NEDO-20566-1-A  
REVISION 1  
77NED304  
CLASS I  
OCTOBER 1982

**GENERAL ELECTRIC COMPANY ANALYTICAL  
MODEL FOR LOSS-OF-COOLANT ANALYSIS  
IN ACCORDANCE WITH 10CFR50 APPENDIX K  
AMENDMENT NO. 1 —  
CALCULATION OF LOW FLOW FILM BOILING  
HEAT TRANSFER FOR BWR LOCA ANALYSIS**

SUBJECT: ACCEPTANCE FOR REFERENCING OF TOPICAL REPORT NEDE-20566P,  
NEDE-20566-1 REVISION 1 AND NEDE-20566-4 REVISION 4

Report No.: NEDO-20566-1, Revision 1

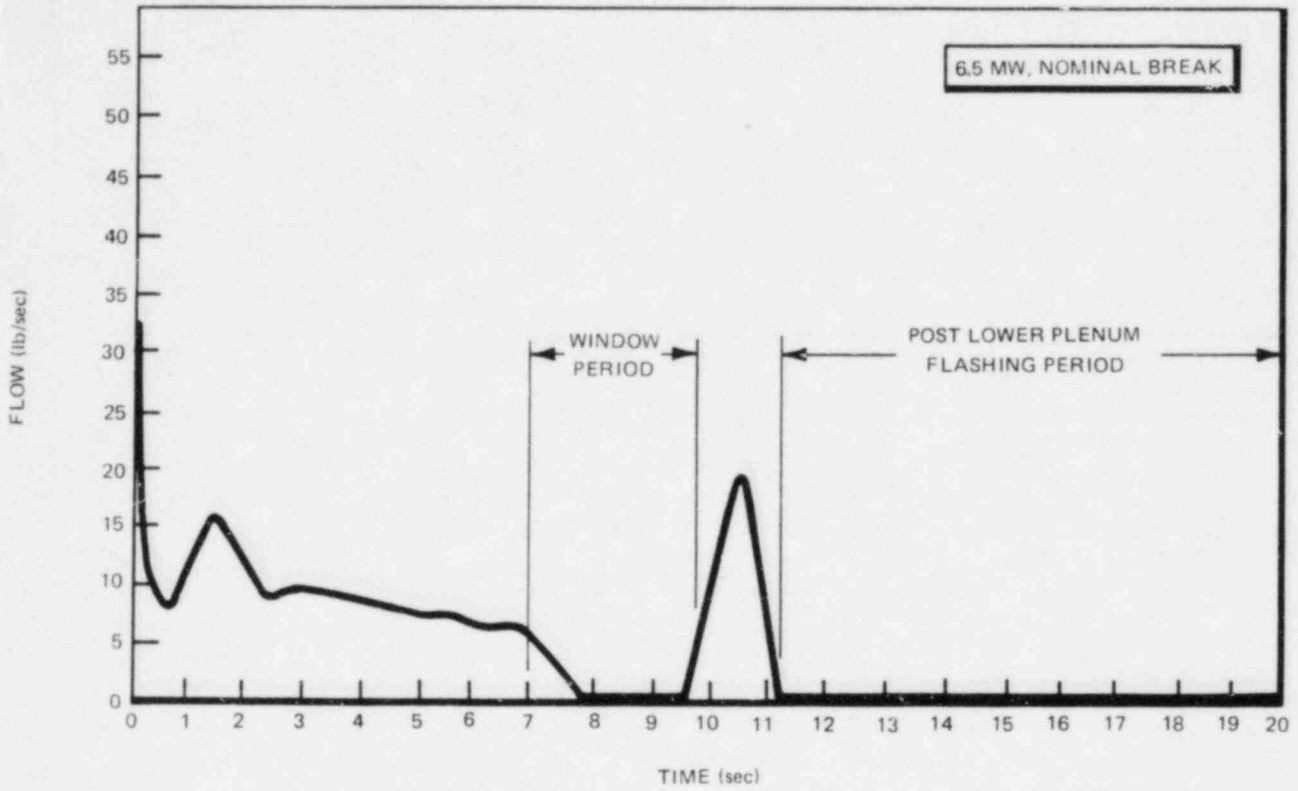
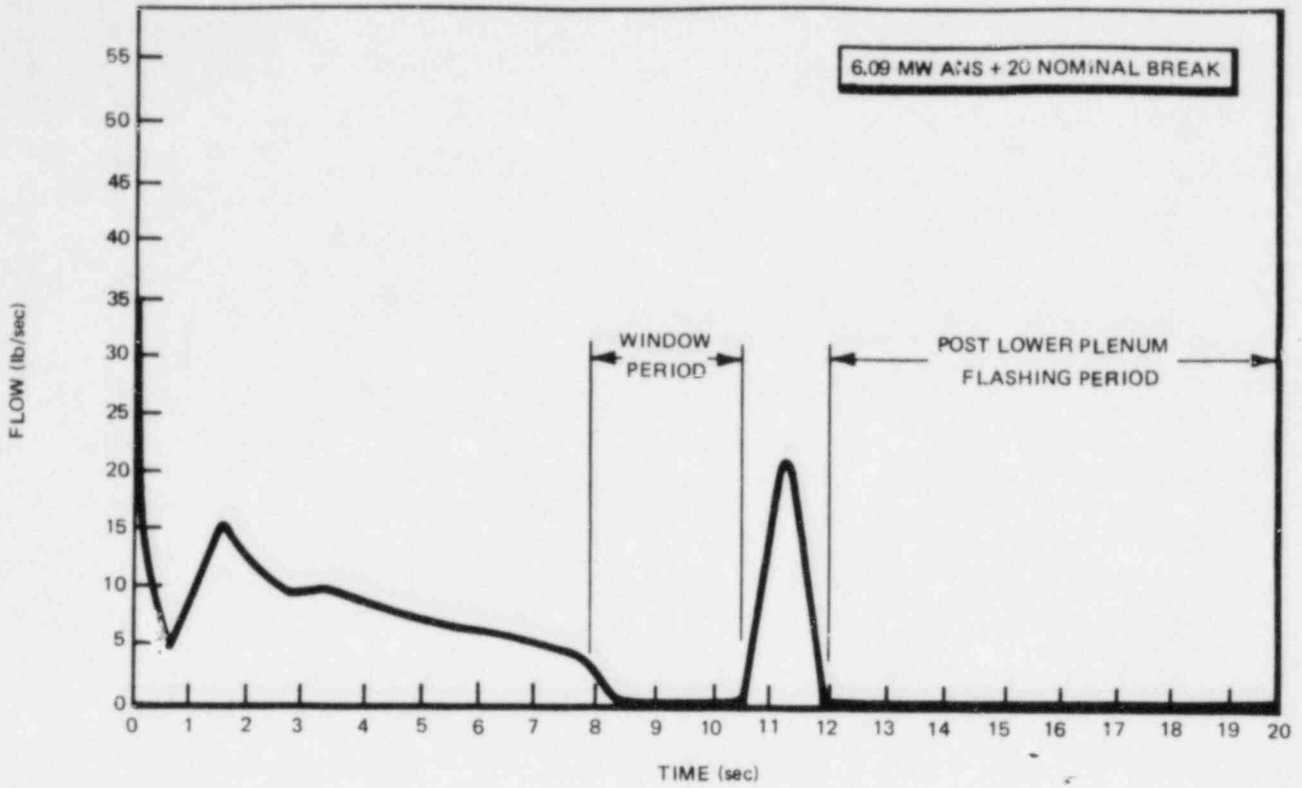
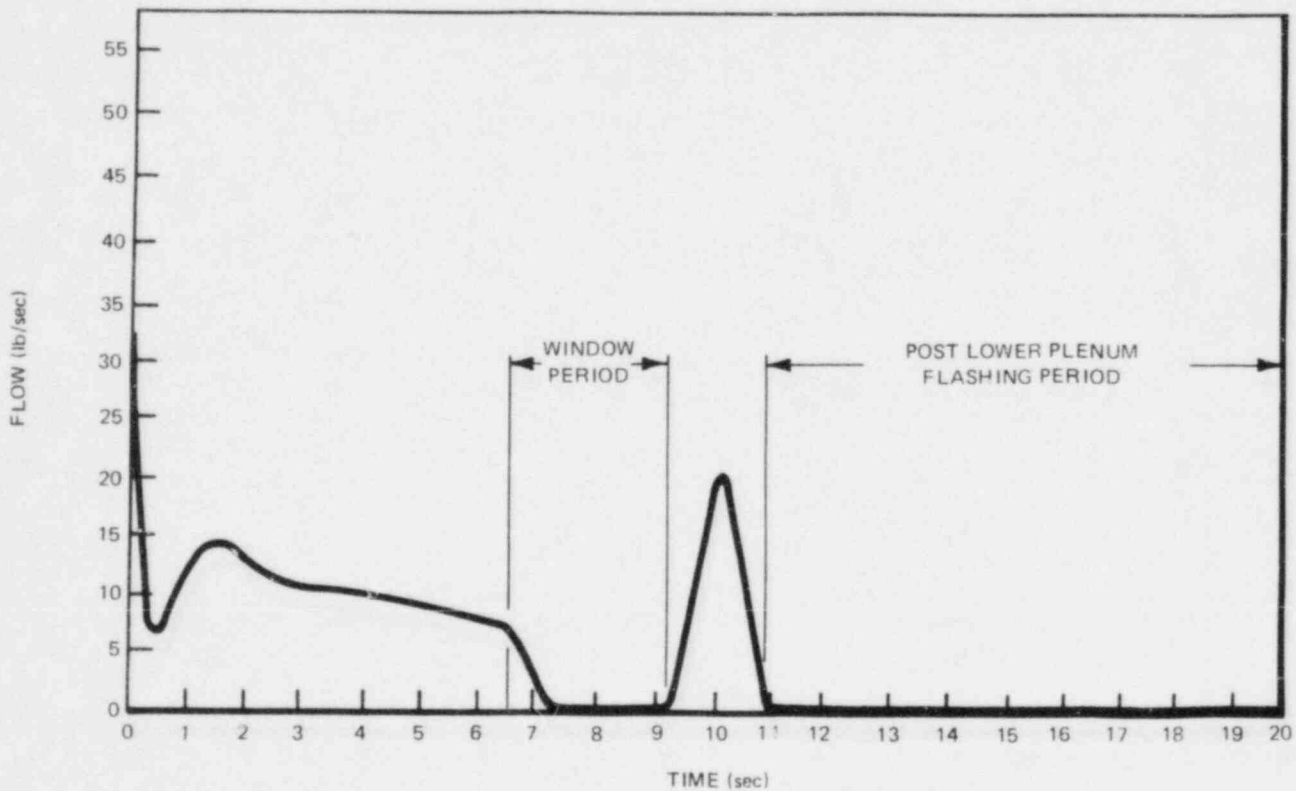
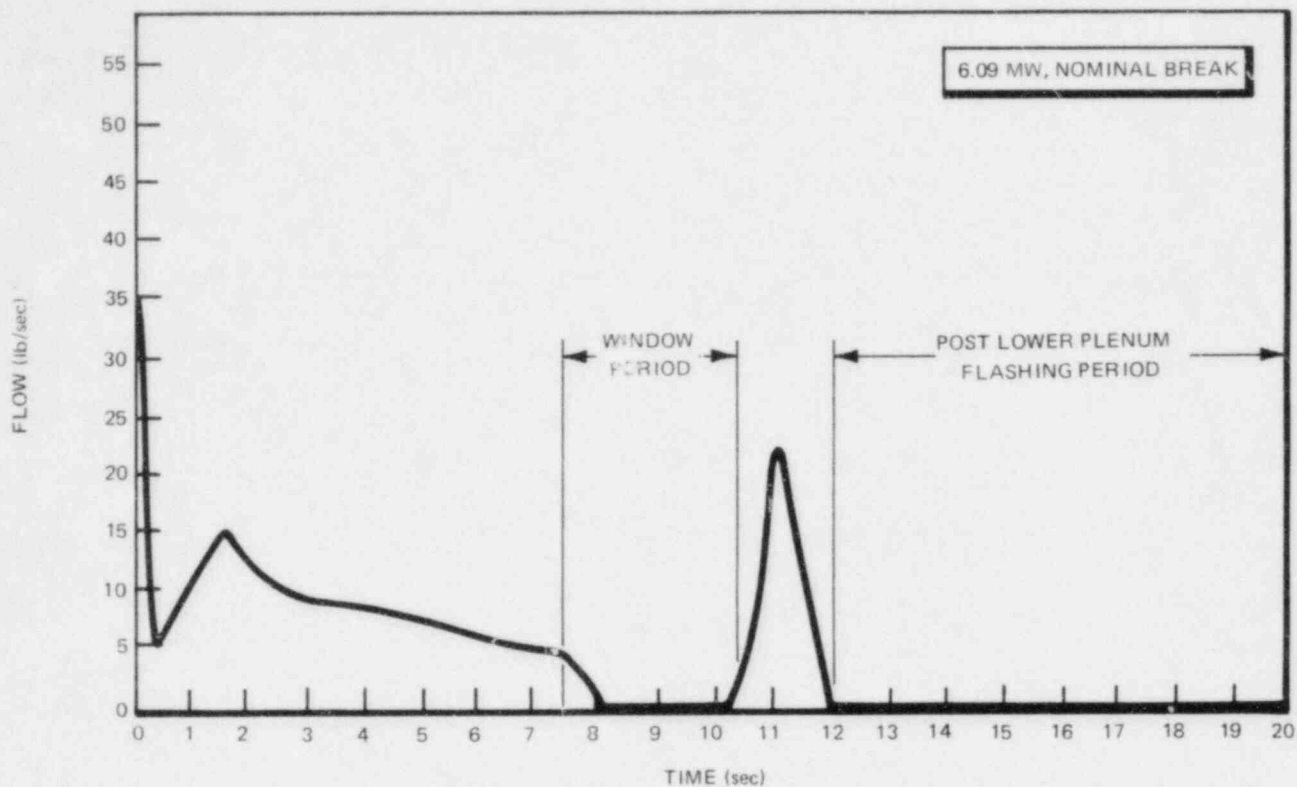
Question 1: Figures 14, 25, 37 and 53 of NEDO-20566-1, Rev. 1 show the inlet flow variation for several tests from the BDHT program. These figures show that low flow exists in the "window" period and in the "post lower plerum flashing" period and thus support the contention that the Modified Bromley correlation is applicable to these periods. However, the same data are given in quarterly reports from the BDHT program and the results are quite different. The curves equivalent to those listed above are GEAP-13317-10, Figure D5.3; GEAP-13317-10, Figure D4.3; GEAP-13317-14, Figure D-2; and GEAP-13317-10, Figure 4-3. The flow data were presumably verified before inclusion in the quarterly reports. Please explain the differences in the data plots and explain why the data are supportive of the use of Modified Bromley.

Subsequently, during the actual BDHT testing, a need for better evaluation of the core inlet flow during the early coastdown and window period (GEAP-13317-10) of the blowdown transient was identified. Special tests (GEAP-13317-10, -11, and -12) were conducted to establish the resolution and the dynamic response of the bundle inlet orifice pressure drop measurement. These tests led to several modifications in the pressure drop measurement arrangements and their installation.

Subsequently, detailed data analyses utilizing the bundle inlet flow measurements were performed with the MAYU-04 (GEAP-23517) code. From these studies it was clear that the indicated bundle inlet flow, as well as the pressure drop measurement from which it was derived, was not reliable during the extremely low flow periods when the measured inlet pressure drop was less than about 0.1 psi. Hence, an alternate method was developed wherein a flow balance in the lower plenum was utilized to provide a better indication of the bundle inlet flow during the window period. Each of the flow components in such a flow balance is large and of higher accuracy than the core inlet. This led to a more reliable evaluation of the core inlet flow than originally reported. The flow balance is derived from the mass balance in the lower plenum, which includes the inlet and outlet flow rates of subcooled water through the jet pumps and bypass region. Such mass balance evaluations for the core inlet flow are compared with those derived from the pressure drop measurement across the inlet orifice in Figures C-1, C-2, and C-3. In each instance the core flows determined for both evaluations agree well except during the window period. For that very low flow period the flow balance method is more reliable. Therefore, the flow evaluations using the flow balance method were utilized in the studies reported in NEDO-20566-1.

the bundle that are less than  $0.1 \times 10^6$  lbm/h-ft<sup>2</sup>. These low mass velocities are typical of gravity-controlled flow, as opposed to forced flow, and provided the locations are in liquid continuum, the corresponding heat transfer rates are characterized by pool boiling or pool film boiling, i.e., Modified Bromley.
